Access Compliance Report

Public Rights-of-Way

Intersection ID: 50998	Main Street: S_TRYON_ST	Cross Street: STEELECROFT_PY	Location: SE
ADA ID: AC6D25B02582	Ramp Type: Perp	Initial Pass/Fail: Fail	Overall Compliance: No
Severity Score: 33.75			
Codes/Mitigation Info/Possible Solution		Field Measurements/Component Compliance

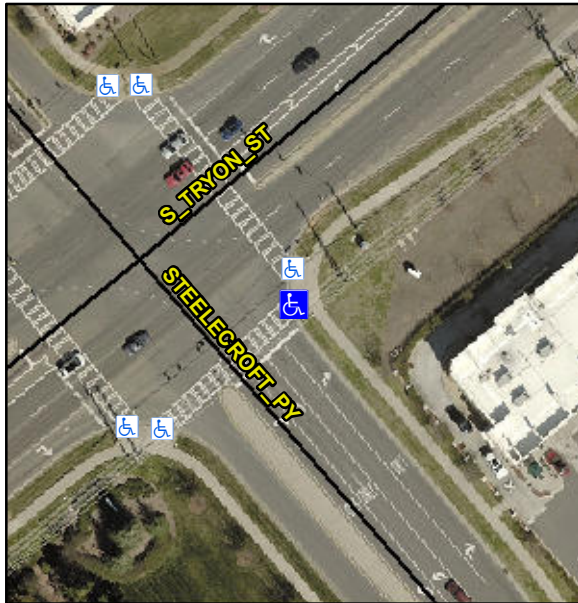
R304.5.1, R304.5.3

Compliance	Description	Data	Compliance	Description	Data
N/A	Ramp Length (in)	95.0	Yes	Ramp Slope (%)	7.5
No	Ramp Width (in)	47.0	No	Ramp XSlope (%)	8.0
N/A	Flare Type LT	N/A	N/A	Flare Type RT	N/A
N/A	Flare Slope LT (%)	N/A	N/A	Flare Slope RT (%)	N/A
N/A	Flare Traversable LT?	N/A	N/A	Flare Traversable RT?	N/A
N/A	Landing Length (in)	N/A	N/A	DWS Provided?	N/A
N/A	Landing Width (in)	N/A	N/A	DWS Contrast?	N/A
N/A	Landing Slope (%)	N/A	N/A	DWS Length (in)	N/A
N/A	Landing X Slope (%)	N/A	N/A	DWS Full Width?	N/A
N/A	Landing Curb? (Y/N)	N/A	N/A	DWS Offset (in)	N/A
N/A	Shared Landing?	N/A			
N/A	Gutter Ponding?	N/A	N/A	Gutter Slope (%)	N/A
N/A	Gutter Lip Ht (in)	N/A	N/A	Gutter X Slope (%)	N/A
N/A	Painted X Walk1?	Yes	N/A	Painted X Walk2?	N/A
	X Walk 1 Direction	To SW		X Walk 2 Direction	N/A
N/A	X Walk 1 Width (in)	112.0	N/A	X Walk 2 Width (in)	N/A
	X Walk 1 Slope (%)	1.3		X Walk 2 Slope (%)	N/A
	X Walk 1 X Slope (%)	5.6		X Walk 2 X Slope (%)	N/A

Remove & Replace Entire Ramp.
